N6702A-02A

Information Only Service Note

N6702A - Low-Profile Modular Power System

Different Color Front Panel LCD Display

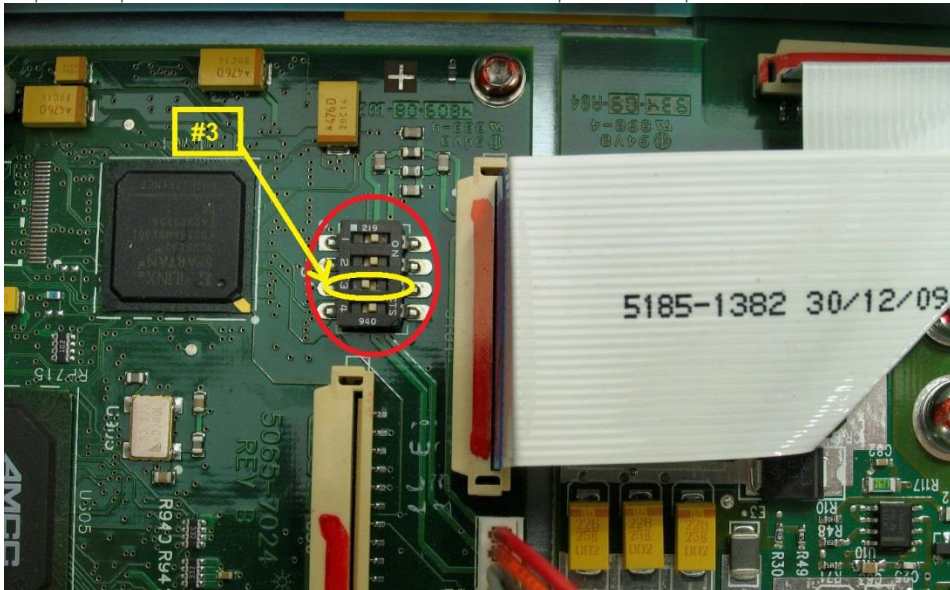
Blue/white Front Panel LCD Display (below) has been obsoleted.

LCD (blue/white display assembly, part no. 2090-1031) has been discontinued by vendor. Replacement assembly (pictured later) is part no. 5067-5993 (amber in color). Difference in color doesn't impact any performance and specification. Unfortunately, this cannot be altered.

- 1) New LCD display (5067-5993) is a mechanical & functional “drop-in” replacement for the original.

- 2) 4-pole dip switch on PPMC PCA must have pole #3 repositioned to “off” as shown below:

- 3) Instrument firmware must be version D.04.01 or newer for proper operation of this display.
